CONSULTANT:		CONSULTANT:		ARCHITECT/ENGINEERS:		Drawing Title EXTERIOR ELEVATIONS		Project Title COMMUNITY LIVING CENTER		Project Number 442-12-357		Office of Construction and Facilities Management	
						<div><div>15031 SOUTH PINE BLVD SUITE 200 PARKER, COLORADO 80138 PH: 303-841-9922 WWW.AES-GFP.COM</div></div>				Building Number COWBOY					
RFI #5		21 APRIL 2017						Approved: Project Director		Location CHEYENNE, WYOMING		Drawing Number			
RFI #4		12 APRIL 2017						SYLVIE RUPP - CFM DIRECTOR				AE201			
RFI #3		31 MARCH 2017						FACILITIES/ENGINEERING		Date		Checked			
RFI #2		24 MARCH 2017						PHONE: 307-778-7550x7267		MARCH 2017		DHH			
REQUEST FOR INFORMATION #1 (RFI #1)		16 MARCH 2017						FAX: 307-287-9725		Drawn		JTB			
Revisions:		Date										Dwg. of		 Department of Veterans Affairs

RFI #5	21 APRIL 2017
RFI #4	12 APRIL 2017
RFI #3	31 MARCH 2017
RFI #2	24 MARCH 2017
REQUEST FOR INFORMATION #1 (RFI #1)	16 MARCH 2017
Revisions:	Date

Project Title
COMMUNITY LIVING CENTER

3 WEST ELEVATION
1/8" = 1'-0"

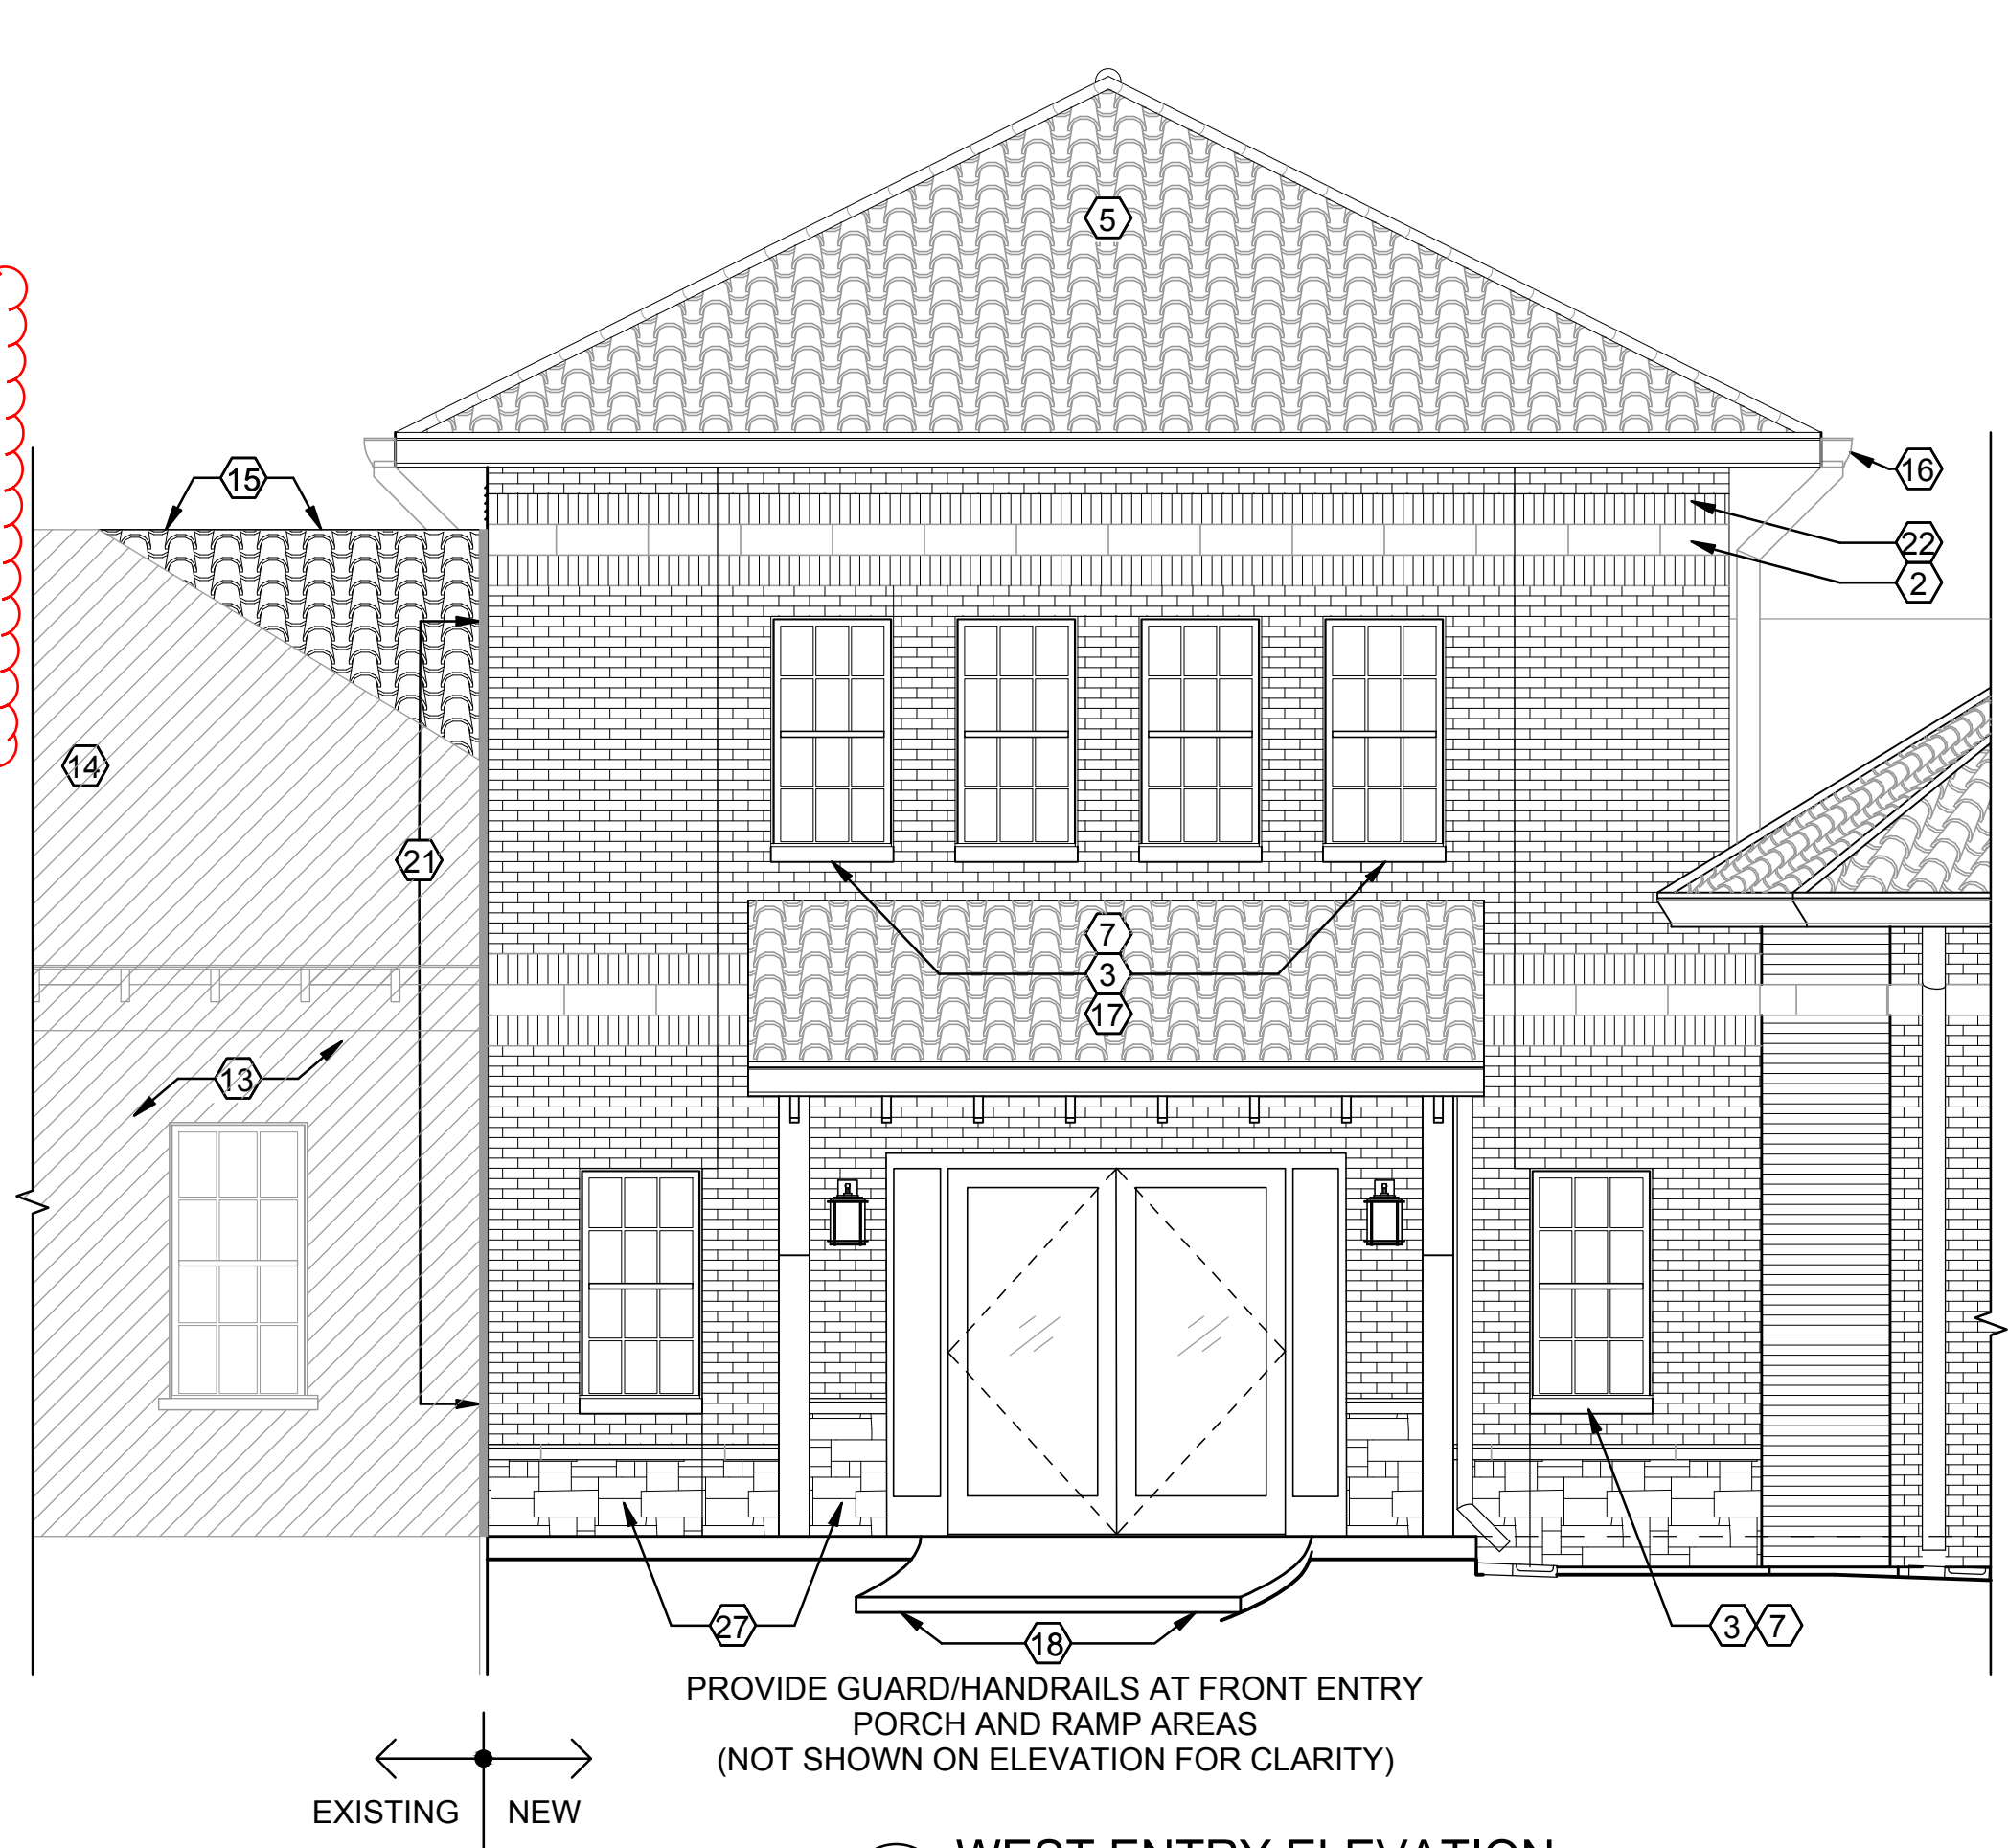
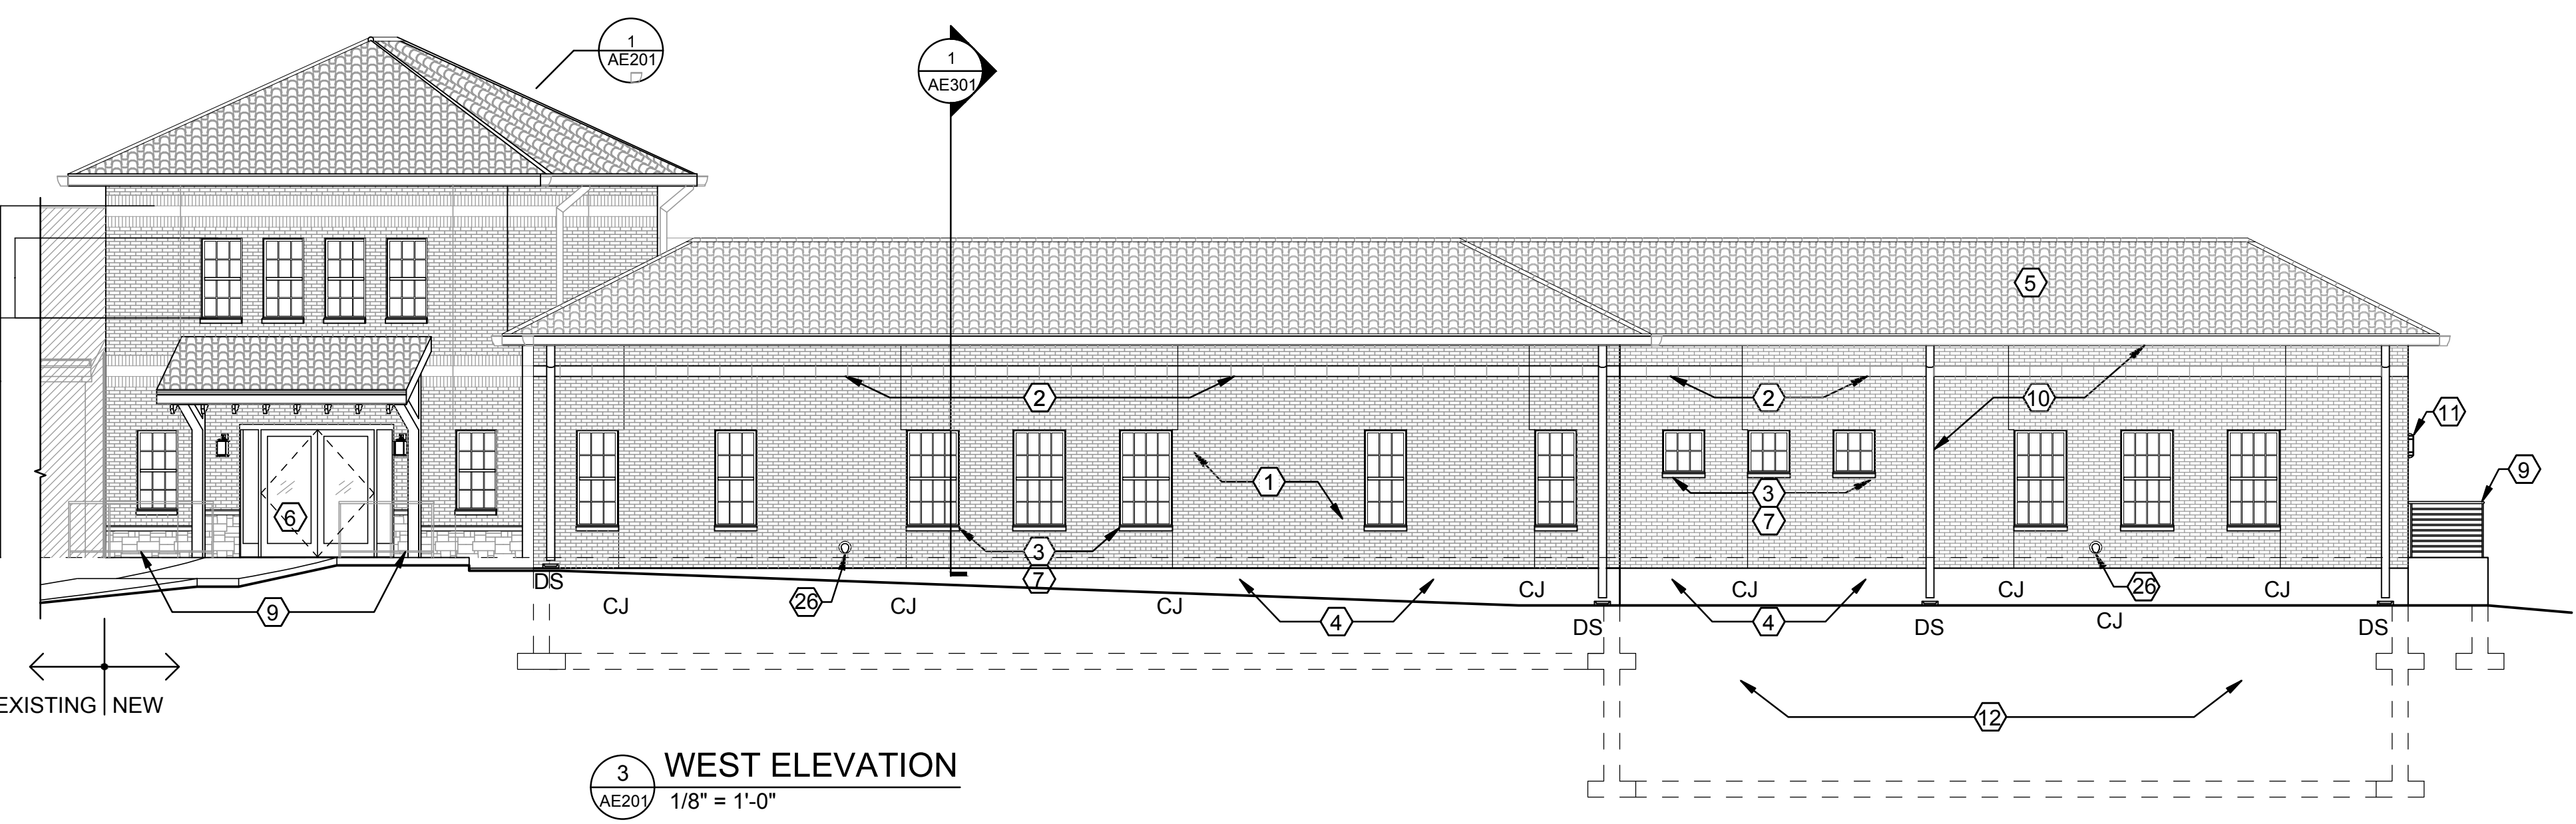
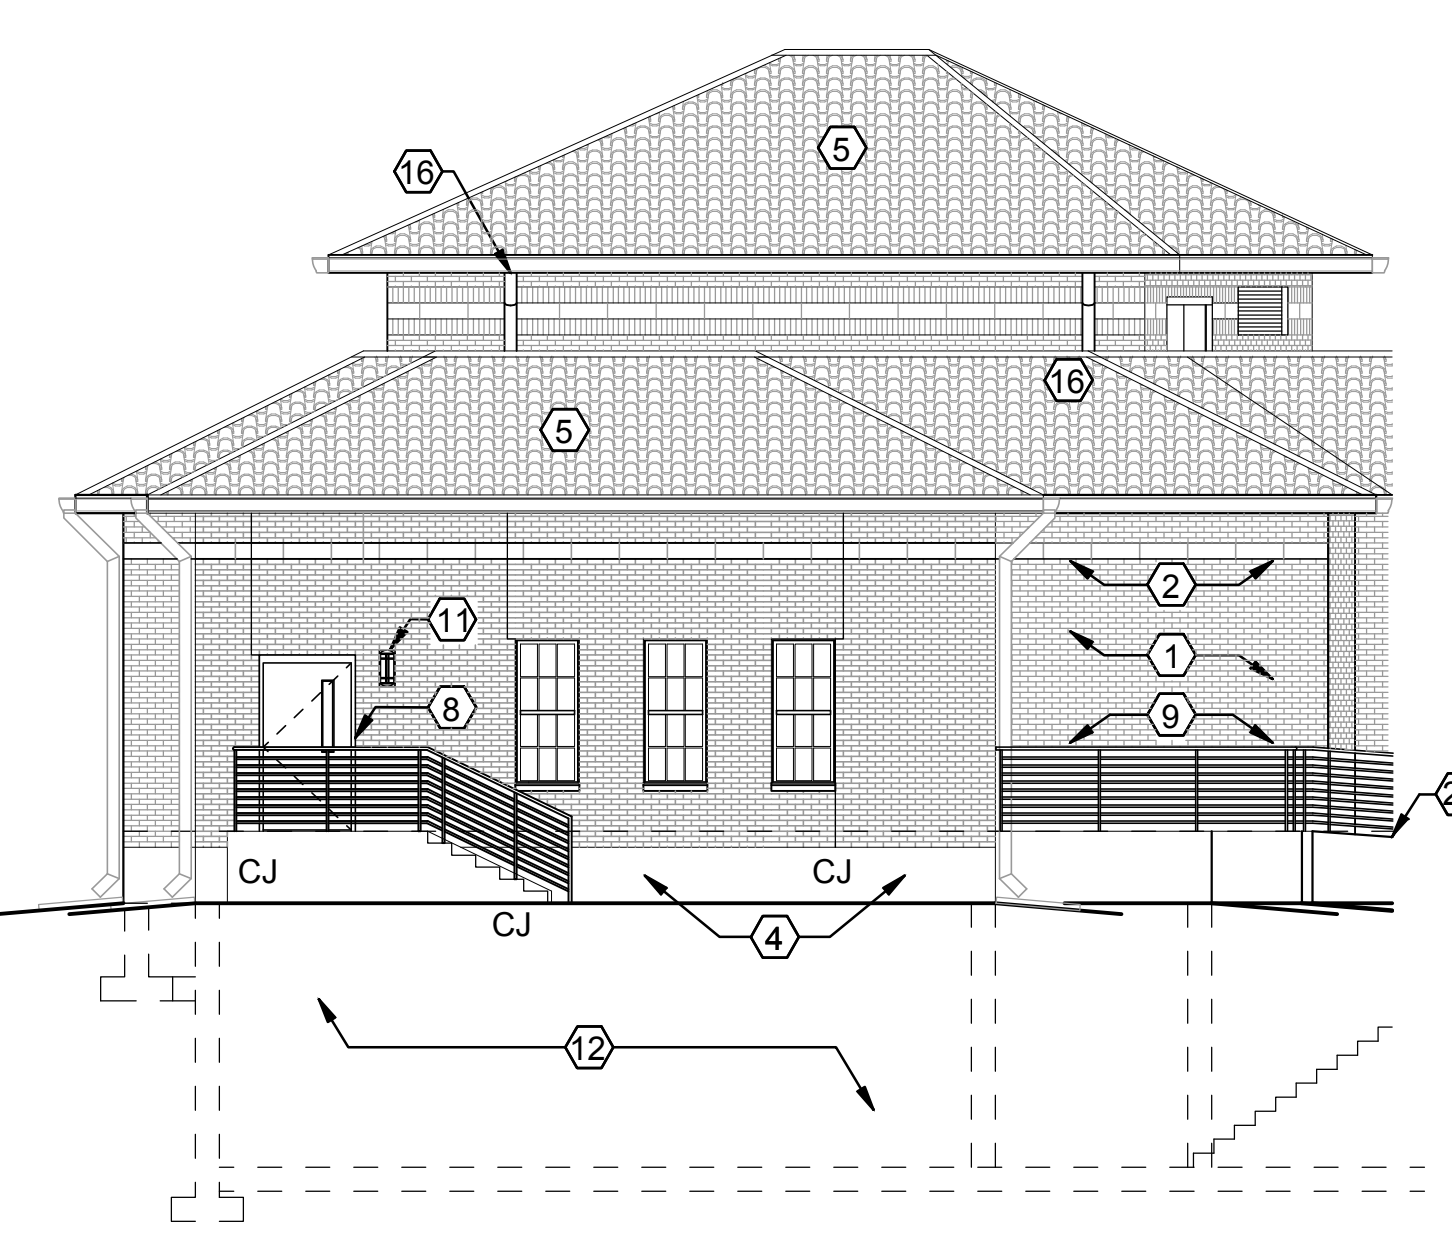
ADJUSTMENT TO SEVERAL CONTROL JOINTS (CJ)
